# STAFF RECOMMENDATION

NCPC File No. 6765

## NEW FORT BELVOIR COMMUNITY HOSPITAL CONCEPT SITE AND BUILDING PLANS Fort Belvoir, Fairfax County, Virginia

August 30, 2007

### LOCATION OF SUGGESTED OPEN SPACE BUFFER BETWEEN SIXTH STREET AND NINTH STREET

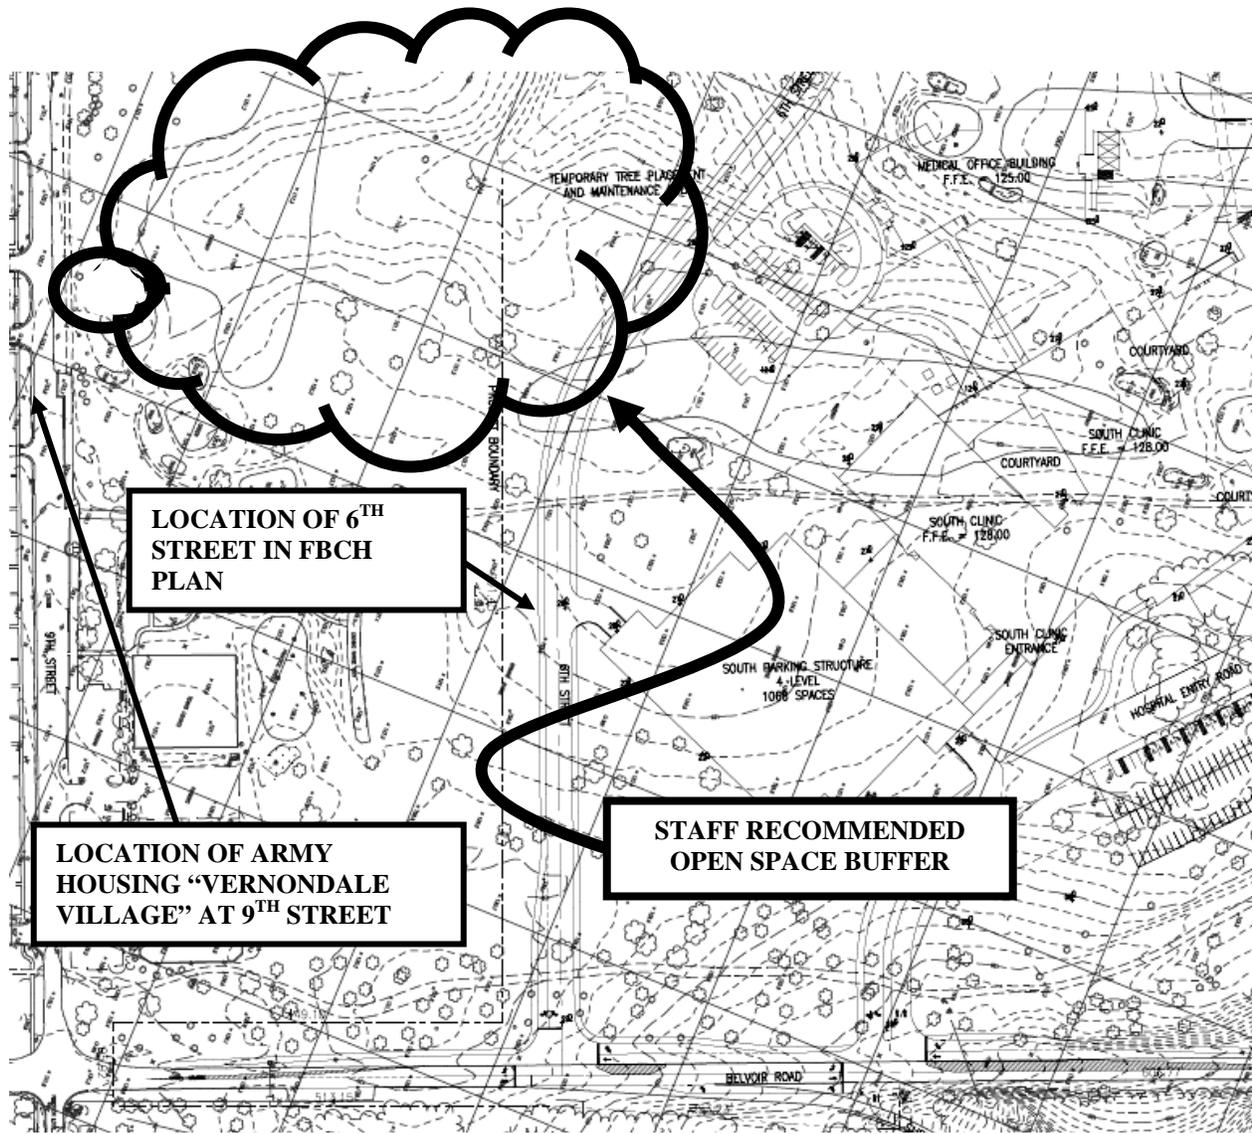
Finally, the presence of the existing residential development across Ninth Street suggests that large scale development at the hospital is potentially intrusive toward this area. **Staff recommends the Commission request the applicant investigate a location and implementation of open space, between the Sixth Street and Ninth Street corridor, with a buffer zone that would serve to protect the residential area along Ninth Street from traffic and service truck noise, emergency sirens, and other activity associated with the hospital location.** Staff believes completion of a buffer zone across from the medical office area toward Ninth Street would be sufficient (see pages 14 and 15).

- The applicant investigate a location and implementation of open space, between the Sixth Street and Ninth Street corridor, with a buffer zone that would serve to protect the residential area along Ninth Street from traffic and service truck noise, emergency sirens, and other activity associated with the hospital location.
